October 6, 2003
WOG-03-510

CE NPSD-1199
Project Number 694

**Subject: Westinghouse Owners Group Response to Request for
Additional Information on CE NPSD-1199, "Model for Failure
of RCP Seals Given Loss of Seal Cooling" (TAC No. MB5803)**

CE NPSD-1199-NP, "RCP Seal Failure Model"
Response to Request for Additional Information dated July 24, 2003

Figure 2.1-1: Idealized RCP Seal Stage Force Balance

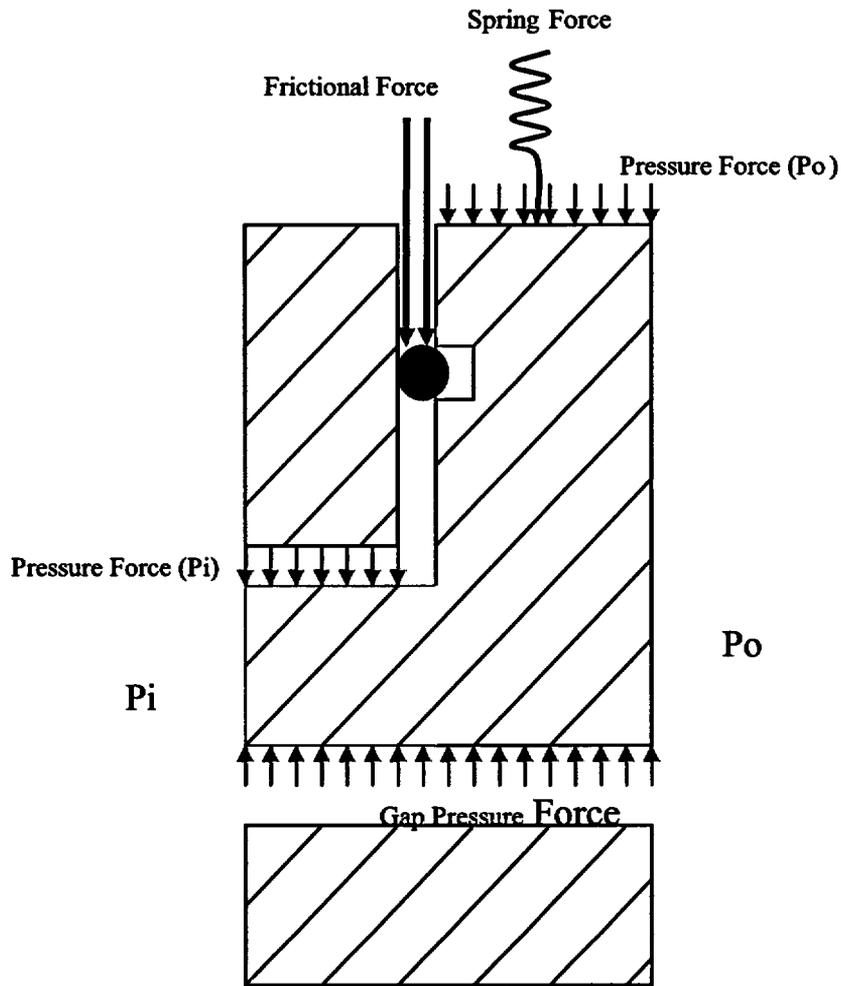
In the response to staffs request for additional information RAI 16 (page 36 of the responses to the RAIs), it is mentioned that when the controlled bleed-off (CBO) is not isolated, the inlet fluid to the vapor seal is not subcooled, but the pressures are not high enough to challenge the vapor seal. However, according to Table 5.3-2a of CE NPSD-1199, the outlet pressure to the vapor seal is less than one-half the inlet pressure to the vapor seal. Thus, neither of the conditions which would ensure the stability of the vapor seal are present and the seal may pop open. Data was discussed in the response to RAI 2 (page 4 of the responses to the RAIs) which indicated that in tests the vapor seal did not pop open. However, there is no subcooling in the case where the CBO is not isolated (fluid is at saturation conditions), so the test results may not be applicable. How then is the probability of failure for the vapor seal, (used, for example, in Table 9.2-15A of the revised Section 9 given in the responses to the RAI) justified?

Evaluation of seal events on CE PWRs indicates that the middle seal stages are the more likely to experience "pop-open." While small leakages may be observed through the vapor seal, no catastrophic failure has been noted. While detailed thermal-hydraulic behaviors could not be confirmed for most of these events, it is expected that vapor seal operation was in or near saturation for conditions where CBO was not isolated. Experimental data with CBO operation is limited. However, tests conducted by Byron-Jackson for the loss of component cooling water (Reference 2.1-1) and for station blackout (Reference 2.1-2) seal performance also indicated periods of two-phase and near two phase conditions in a vapor seal while seal leakage remained small (< 0.5 gpm). Specifically in one loss of coolant test the RCP seal cartridge was operated for a period of 30 minutes without seal cooling. The seal cartridge remained operational and the controlled bleedoff (CBO) was not isolated during the test interval. A review of the seal temperature and pressure data indicates a period of ~10 minutes where the vapor cavity was nearly saturated (within ~10°F of saturation) or saturated. Vapor seal leakage measurements conducted at the time indicated seal leakages < 0.26 gpm. No "pop-open" behavior was observed, even though the backpressure to vapor seal cavity pressure ratio was much less than one half. The total upward force (F_{up}) exerted by the fluid in the seal gap was compared to the total downward (restorative) force (F_{wt}) acting on the RCP seal upper face for the N-9000 seal design. This comparison demonstrated that at these lower absolute pressure conditions the upward force generated in the seal by the seal leakage is insufficient to overcome the downward seal force and hence the seal would not "pop-open."

The conceptual seal design is presented in Figure 2.1-1. The downward force is a result of the combined upstream and downstream pressure loads on associated areas, friction and spring load. The upward (or opening) force is based on the fluid pressure in the seal gap. The capability of the seal to remain closed under a pressure differential is based on a balance between the total downward force (F_{tot}) and upward gap pressure force (F_{up}) assuming that the pressure of a two-phase mixture results in a critical flow condition in the seal gap.

Fig. 2.3-1: Value of F_b^2 as a Function of Pressure and Mass Quality (Martinelli-Nelson)

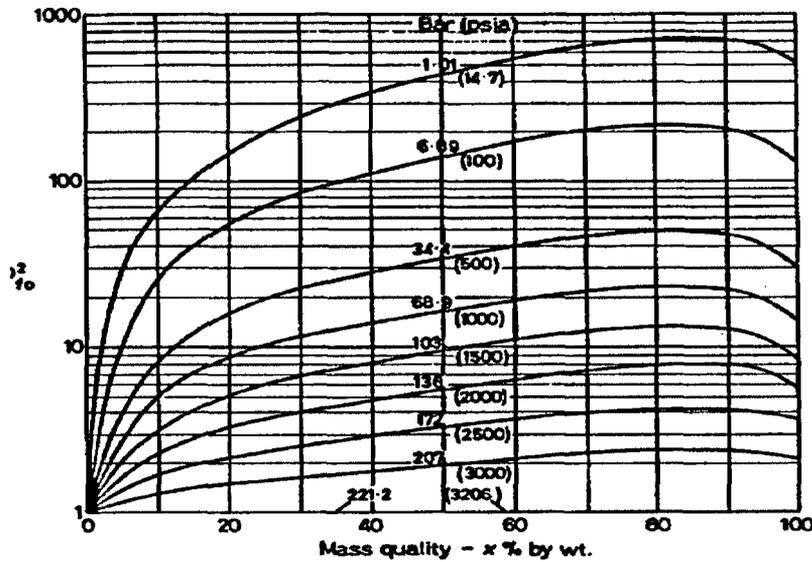
Table 5.3-2a of CE NPSD-1199-P, for post-accident conditions following a station blackout (SBO) event, gives the pressures and temperatures at the inlets to the various seal stages. Consider the case where the CBO is not isolated. Here, the pressure is assumed to drop uniformly across the first three seal stages. The pressures given in Table 5.3-2a of CE NPSD-1199-P are based on the assumption of a uniform pressure drop across the first 3 stages. This is a reasonable assumption for normal operation. However, as several stages will experience two phase conditions, the pressure drops in the pressure breakdown devices will be influenced by flashing. This is particularly significant for those seal stages that appear to indicate the presence of a superheated condition. Under these conditions the pressure drop across the various seal stages will not be uniform. Likely, the flow resistance will be greater where saturated and supersaturated conditions occur. The flow model has to take into account the flashing of the water in the pressure breakdown devices and controlled bleed-off line. Once the pressures are recalculated, the probability of seal failure may change, and the applicability of loss of seal cooling events may be affected. Please analyze.

To demonstrate the impact of two-phase flow through the seal pressure breakdown devices (PBDs) and controlled bleedoff (CBO) line, a limited scope analysis was performed. The intent of the calculation was to predict the impact of the emergence of two-phase conditions on the RCP seal stage pressure distribution and the pressure drop in the CBO line. The calculation assumes the CBO line is not isolated and the enthalpy losses of the liquid in the seal are negligible. The CE NSSS RCP seal design is such that the seal stage pressure drops are controlled by the PBD flow. The pressure drop through the PBD are calculated using the Martinelli-Nelson two-phase flow multiplier (Reference 2.3-1, Two-phase multiplier charts are reproduced below, see Figure 2.3-1). This correlation provides the two-phase multiplier ($F_{2\phi}$) as a function of pressure and mixture quality.

Using this methodology, revised pressure drops were calculated for the various seal stages. Since the RCS and downstream CBO discharge pressure at the volume control tank are relatively fixed, increasing the PBD resistance across saturated and nearly saturated stages will both (1) reduce the CBO flow and (2) skew the pressure distribution such that the larger pressure losses will be taken across the third stage (last PBD). A comparison of the linear single-phase distribution and the alternative distribution accounting for two-phase flow phenomena is presented in Table 2.3-1. Note that the effect of the increased resistance is to reduce the pressure drop across seal stages 1 and 2, further stabilizing both.
